STAFF REPORT
COMMUNITY DEVELOPMENT DEPARTMENT

HEARING DATE: December 1, 2020

SUBJECT: H-2020-0064
 Pura Vida Ridge Ranch

Phasing Plan

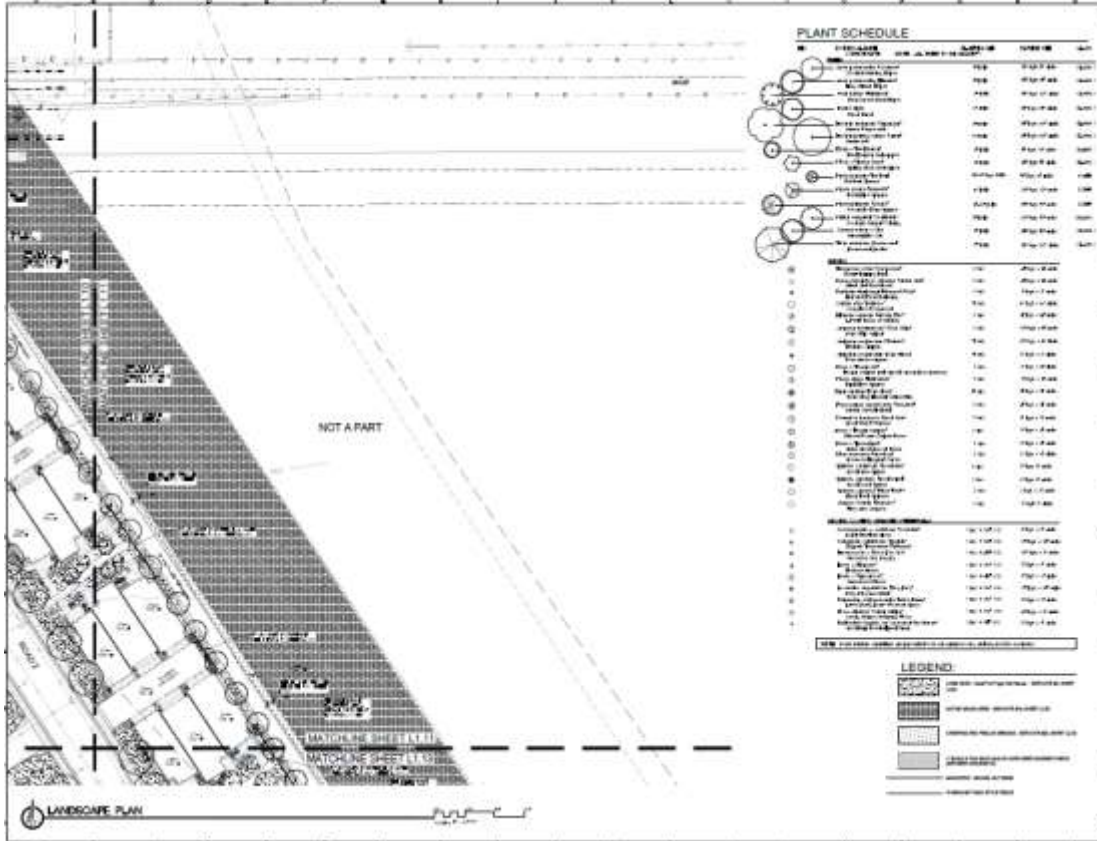
Phasing: A phasing plan was submitted that depicts four (4) phases of development (see Section VIII.B). The first phase is nearest Lake Hazel Rd. with subsequent phases progressing to the south with the last phase at the southwest corner of the site which requires a public street access to be provided from the south. The Fire Dept. is requiring secondary access to be provided from the east or south (or other means as agreeable by the Fire Dept.) prior to development of Phases 2 or 3.

Emergency access should be provided in accord with the phasing plan approved by the Fire Dept. included in Section VIII.B. **The Applicant should coordinate with Terri Ricks and Fire Dept. for**

- 1.4 The water mainline at the southwest corner must be connected at the bottom of the hill to the rest of the subdivision.
- 1.5 The secondary water connection must be completed in phase two, either through the adjacent church property to E. Lake Hazel Rd, OR through the property to the south to S Eagle Rd. This condition reflects MFD's requirement stated on the phasing plan submitted with this record

L.1.11

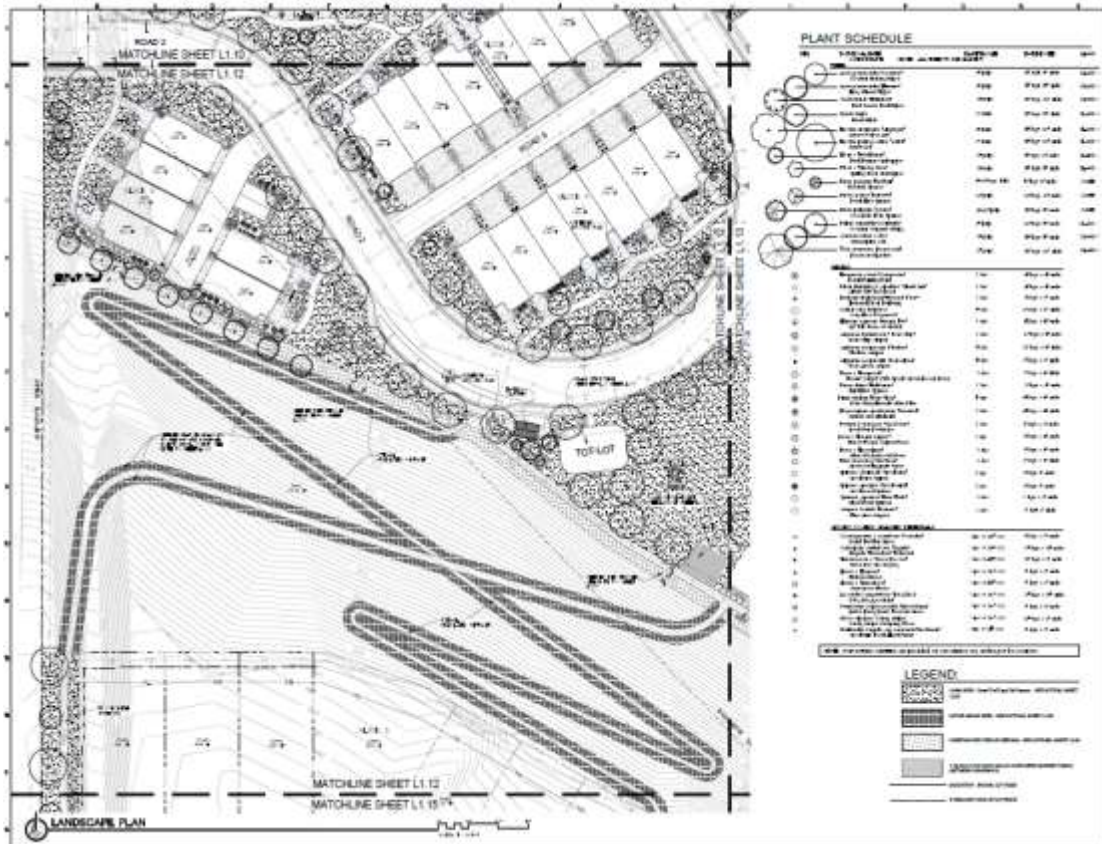
A 35-foot wide street buffer is required along E. Lake Hazel Rd., an arterial street and entryway corridor, per UDC Table 11-2A-7, landscaped per the standards listed in UDC 11-3B-7C as proposed. A berm and an additional 10 trees are proposed above the minimum requirement. **Bushes should be added within the buffer in accord with UDC 11-3B-7C.3, which requires a combination of trees and shrubs along with lawn or other vegetative groundcover.**

The Applicant is not proposing to landscape or provide irrigation sprinklers on the hillside and proposes to leave the area natural and unimproved. The Applicant states that low growing vegetation currently exists that doesn't require supplemental moisture and installing an irrigation system would cause unnecessary damage to the hillside and that the Homeowner's Association (HOA) will be responsible for reducing fuels on an annual basis at a minimum.

Staff and the Fire Dept. is very concerned about the potential danger of wildfires in this area. Therefore, the Fire Dept. is requiring defensible space to be provided – a minimum of 30’ (and possibly more for steep topography) from all structures to the undeveloped, natural open space – plantings within this area should be fire-resistant (see Section IX.C for more information). A wildfire safety plan is required to be approved by the Fire Dept. prior to approval of the first final plat. A copy of the approved plan should be included in the CC&R’s for the subdivision.

All fencing is required to comply with the standards listed in UDC 11-3A-7. No fencing is proposed on the landscape plan. **The Developer is required to construct fencing abutting pathways and common open space lots to distinguish common from private areas per the standards listed in UDC 11-3A-7A.7. Fencing in accord with this standard should be depicted on a revised landscape plan.**

- a. Depict bushes within the buffer along E. Lake Hazel Rd. in accord with UDC 11-3B-7C.3.
 - b. Depict fencing abutting pathways and common open space lots to distinguish common from private areas per the standards listed in UDC 11-3A-7A.7; include a detail of the proposed fence.

- c. Depict a minimum 30-foot wide (may be increased to account for steep topography) defensible space extending out from any part of adjacent structures to the hillside in accord with Fire Dept. comments in Section IX.C. Hazardous and fire-prone vegetation shall be prohibited in this area and only fire resistant plants should be utilized for landscaping in this area.

F. Parking Exhibit (REVISED)

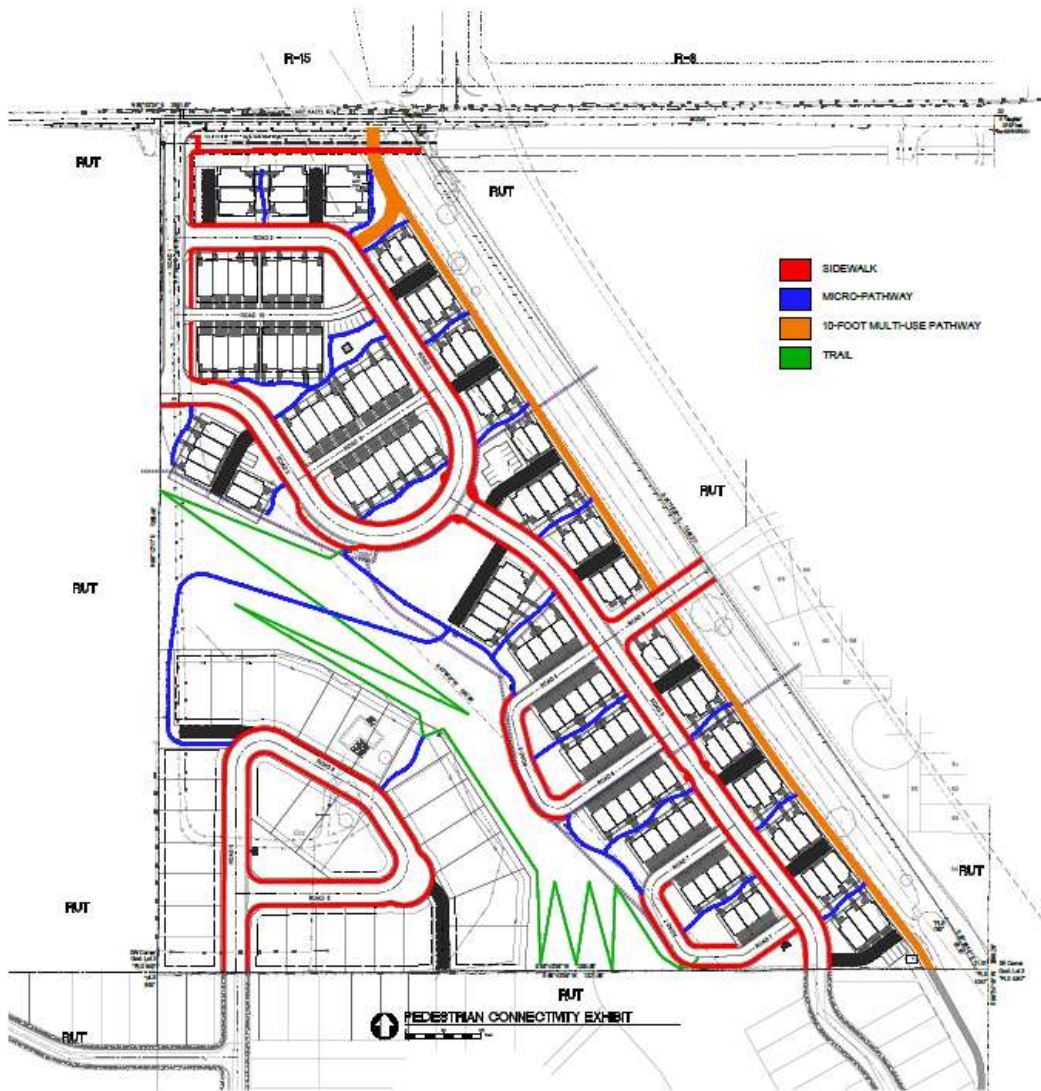
The Applicant is proposing 20’ long x 18’ wide parking pads, which are 2’ less in width than required. The parking pads should be revised to be 20’ x 20’ in accord with UDC Table 11-3C-6.

On-street parking is allowed with 33’ wide street sections but not with 24’ street sections (i.e. Roads 4, 6 and 7); therefore, “No Parking” signs shall be erected along these streets.

16. The parking pads for individual lots shall be revised to be 20' x 20' in accord with UDC Table 11-3C-6.
17. An exception was approved to UDC 11-3A-17D, which requires sidewalks to be constructed on both sides of all public streets, to only require sidewalks along the east sides of the 24' wide street sections (i.e. Roads 4, 6 and 7) adjacent to the parking areas as depicted on the Pedestrian Connectivity Plan in Section VIII.G *and* as required by ACHD (i.e. extend the sidewalks on the east sides of Roads 4 and 6 along the entire common lot/parking area).

NEW HOME PRODUCT

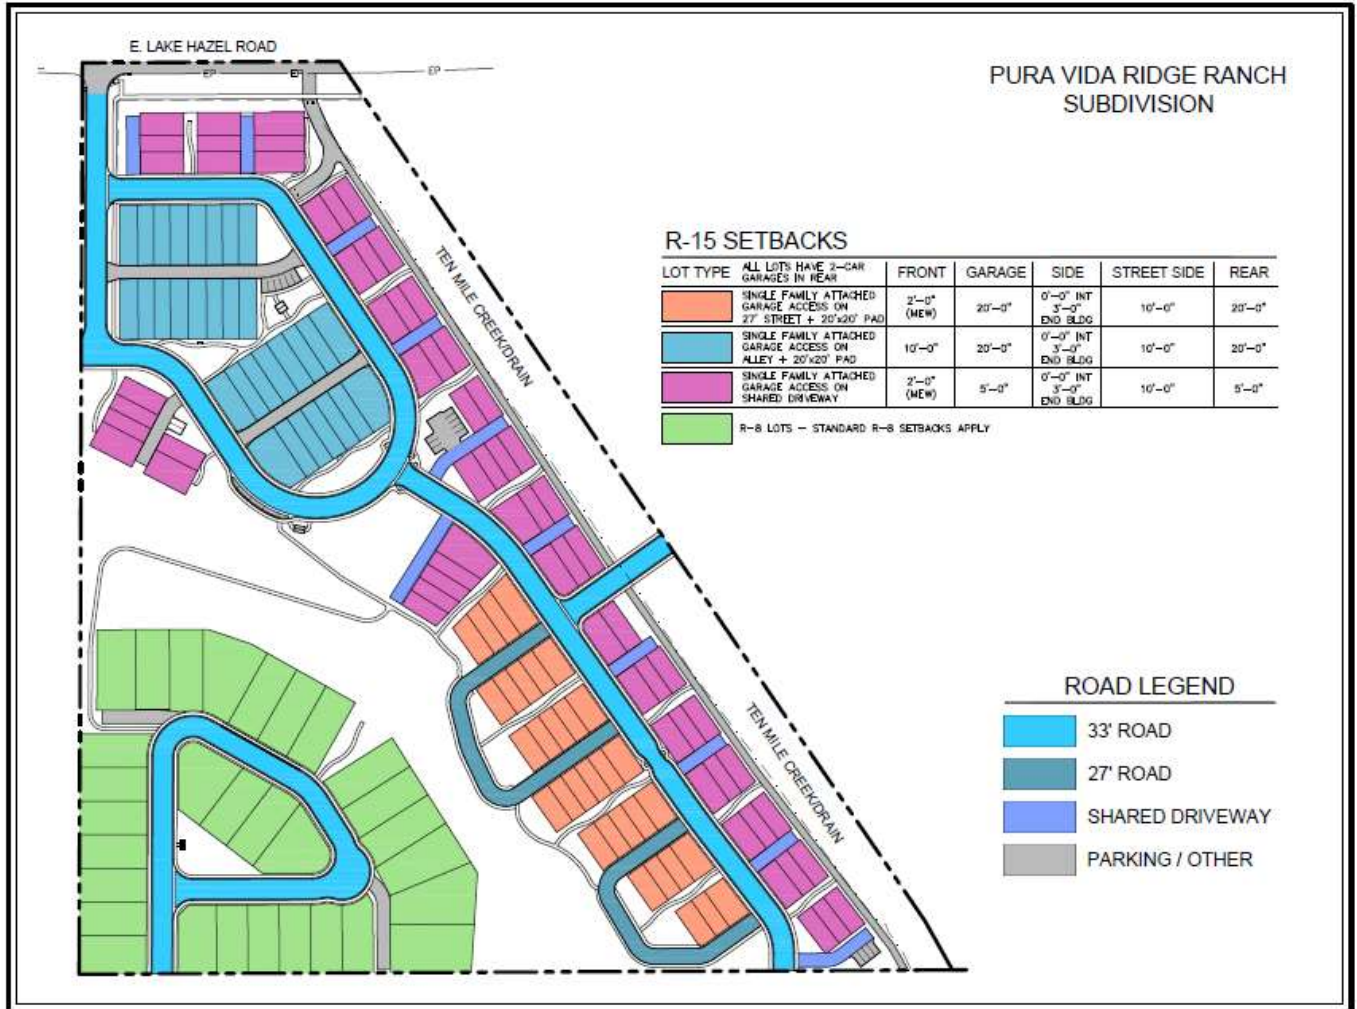
4. Commission change(s) to Staff recommendation:
- a. In favor of the 3-story product type with the flat roof but wanted the design to tie in better with the other units – updated elevations should be submitted prior to the Council hearing.

- b. The Applicant is submitting revised elevations for the 3-story units prior to the Council hearing and requests approval to submit design guidelines for the overall development after the hearing for inclusion in the DA.
